Office Action Summary	Application No. 10/534,495	Applicant(s) LEWIN ET AL.	
	Examiner ROY PUNNOOSE	Art Unit 2886

DETAILED ACTION

Figure 1. Structured light generating apparatus (JP 62007019 A)

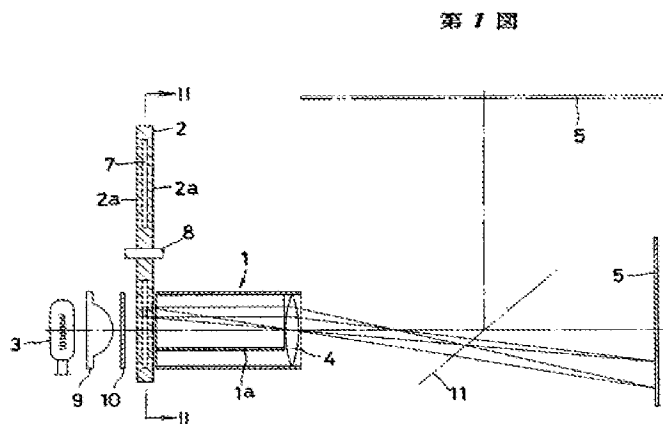
27. Claim 1 is rejected because Kuchitsu teaches of:

A structured light generator (**see Fig.1**) for illuminating a scene **5** comprising;

a light source **3, 6** (see Figures 1 and 2) arranged to illuminate part of the input face of a light guide **1a**, the light guide **1a** comprising a tube having substantially reflective sides;
and,

projection optics **4** arranged together with said light source **3, 6** and said light guide **1a** so as to project an array of distinct images (**see Fig.3**) of the light source **3, 6** towards the scene **5** (**see abstract**).

Figure 2. Structured light generating apparatus (JP 62007019 A)

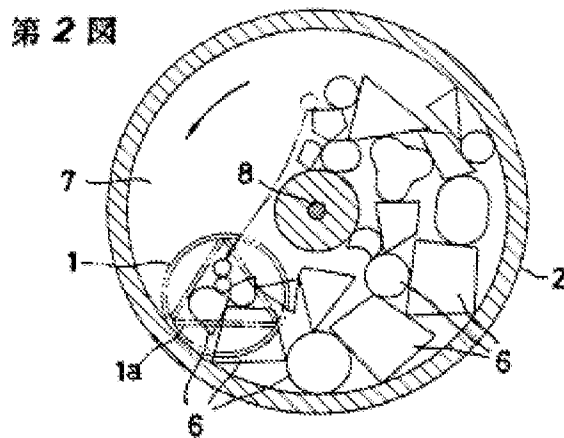
Note: It is noted that colored transparent small chips 6 in combination with lamp 3 effectively forms a source of light to illuminate part of the input face of the light guide 1a having reflective sides.

Figure 4. Structured light generating apparatus (JP 62007019 A)

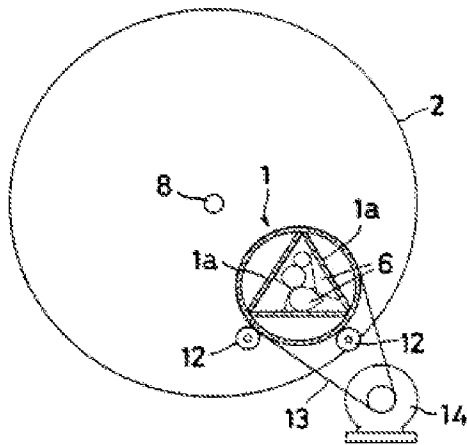
32. **Claim 16** is rejected for the same reasons of rejection of claim 1 as above and because Kuchitsu teaches that the light source has a non-circular shape. It is evident from Figure 4 that the colored transparent small chips **6** which in combination with lamp **3** effectively forms a source of

light to illuminate part of the input face of the light guide **1a** have non-circular shape (see second paragraph on page 9 of Kuchitsu translation and Figure 4).

33. **Claim 17** is rejected for the same reasons of rejection of claim 16 as above and because Kuchitsu teaches that the light source has a non-circular shape that is not symmetric about the axes of reflection of the light guide. It is evident from Figure 4 that the colored transparent small chips **6** which in combination with lamp **3** effectively forms a source of light to illuminate part of the input face of the light guide **1a** have non-circular shape and not symmetric about the axes of reflection of the light guide (see second paragraph on page 9 of Kuchitsu translation and Figure 4).

34. **Claim 18** is rejected for the same reasons of rejection of claim 1 as above and because Kuchitsu teaches of more than one light source, each light source arranged to illuminate part of the input face of the light guide. It is evident from Figure 4 that the colored transparent small chips **6**

36. **Claim 22** is rejected for the same reasons of rejection of claim 18 as above and because Kuchitsu teaches of at least one light source is shaped differently from another light source. It is evident from Figure 4 that each of the colored transparent small chips **6** *having different shapes* which in combination with lamp **3** effectively forms a source of light to illuminate part of the input face of the light guide **1a** (see second paragraph on page 9 of Kuchitsu translation and Figure 4).

37. **Claim 23** is rejected for the same reasons of rejection of claim 18 as above and because Kuchitsu teaches that at least one light source has a shape that is not symmetric about a reflection axis of the light guide. It is evident from Figure 4 that each of the colored transparent small chips **6** which in combination with lamp **3** effectively forms a source of light to illuminate part of the input face of the light guide **1a** (see second paragraph on page 9 of Kuchitsu translation and Figure 4) and is not symmetric about a reflection axis of the light guide.

US 6,350,041 B1

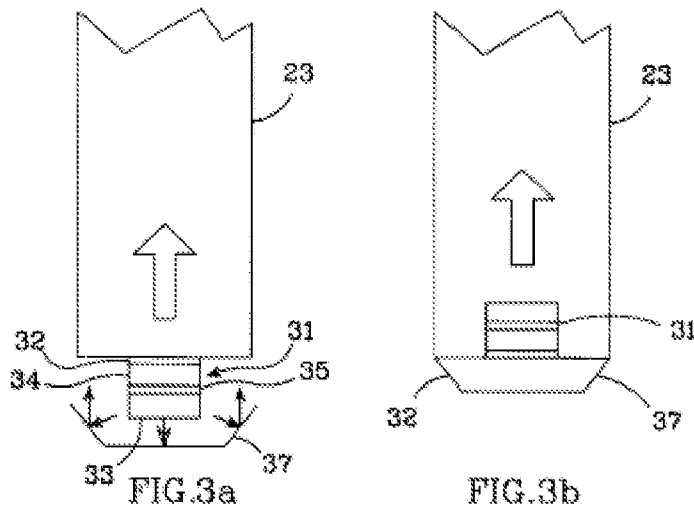
- B. Tarsa et al (Tarsa hereinafter) teaches of various locations at which light source(s) 31 may be placed/arranged (see col.5, line 34 - col.6, line 47; Figures 3a-3d), and specifically at least one light source 31 located within the light guide (see Figure 3b), in a structured light generator for projecting patterns of light (see col.3, lines 17-18) towards a scene.

- C. In view of Tarsa's teaching of having at least one light source located within the light guide and various other arrangements, it would have been obvious to one of ordinary skill in the art at the time the invention was made to incorporate any of the particular placement/arrangement of light source(s) as shown by Tarsa in Figures 3a-3d, *or a*

combination thereof, to have one light source located within the light guide at a different depth to another light source, into Kuchitsu's apparatus due to the fact that it would provide an increased number of complex projection patterns in a structured light generator for projecting an array of distinct images/patterns of light source towards a scene for displaying complex patterns of light on the scene for various purposes.

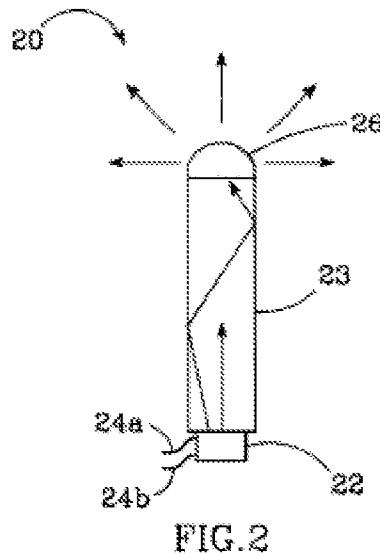
- A. Kuchitsu teach all claim limitations except that the light sources are arranged in a regular pattern in a structured light generator for projecting an array of distinct images of light source towards a scene for displaying complex patterns of light on the scene for various purposes.

- B. Tiao et al (Tiao hereinafter) teaches of an apparatus comprising light sources 50a, 202, 202a that are arranged in a regular pattern (see Figures 2A, 2B and 11) in a structured light generator for projecting images of light source towards a screen/scene (see title and abstract, specifically image projection).

- C. In view of Tiao's teaching, it would have been obvious to one of ordinary skill in the art at the time the invention was made to incorporate light sources arranged in a regular pattern into Kuchitsu's apparatus due to the fact that it would provide more complex light projection patterns from a source light pattern in a structured light generator for projecting an array of distinct images/patterns of light source towards a scene/screen for displaying complex patterns of light on the scene/screen for various purposes.

FIG 15

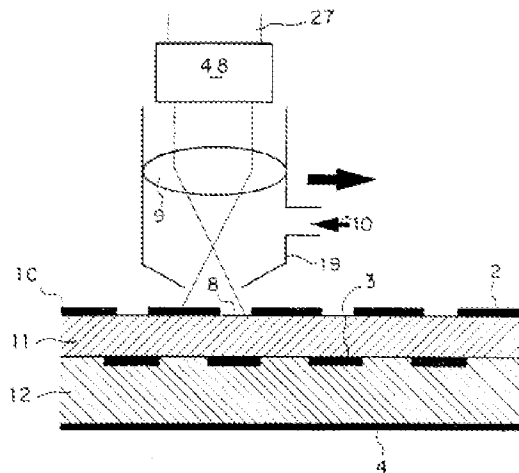
- A. Kuchitsu and Tiao teach all claim limitations except for (a) a specific cross sectional area of the light guide as claimed in claim 5, (b) a specific length of the light guide as claimed in claim 8, and (c) the light sources are arranged such that different arrangements of sources can be used to provide differing spot densities, in a structured light generator for projecting an array of distinct images of light source towards a scene for displaying complex patterns of light on the scene for various purposes.
- B. Kurosawa et al (Kurosawa hereinafter) teaches of an apparatus comprising a kaleidoscope 48 in which the light source and light guide dimensions of the kaleidoscope are selected to provide a desired spot sizes and therefore spot densities (see col.16, lines 1-4, lines 18-22,

and Figure 15) in a structured light generator for projecting images of light source towards a scene.

C. In view of Kurosawa's teaching, it would have been obvious to one of ordinary skill in the art at the time the invention was made to incorporate Kurosawa's teachings into Kuchitsu's apparatus due to the fact that it would provide an apparatus that can project precise light patterns onto a scene/screen in a structured light generator for projecting an array of distinct images/patterns of light source towards a scene/screen for displaying complex patterns of light on the scene/screen for various purposes.

FIG. 2

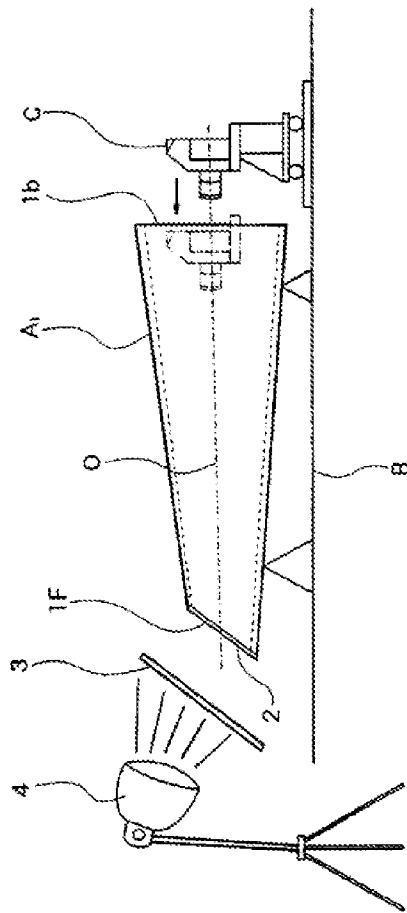
- A. Kuchitsu and Tiao teach all claim limitations except that a homogeniser is disposed between the light source and the mask, in a structured light generator for projecting an array of distinct images of light source towards a scene for displaying complex patterns of light on the scene for various purposes.
- B. Shimomukai teaches of an apparatus comprising a kaleidoscope in which a homogenizer/diffuser 3 (see abstract; col.6, lines 57-64; Figure 2) is disposed between the light source and the input face of the kaleidoscope, in a structured light generator for projecting an array of distinct images of light source towards a scene for displaying complex patterns of light on the scene for various purposes.

C. In view of Shimomukai's teaching, it would have been obvious to one of ordinary skill in the art at the time the invention was made to incorporate Shimomukai's teachings into Kuchitsu's apparatus due to the fact that it would provide an apparatus that can project soft light patterns onto a scene/screen in a structured light generator for projecting an array of distinct soft images/patterns of light source towards a scene/screen for displaying complex patterns of light on the scene/screen for various purposes.
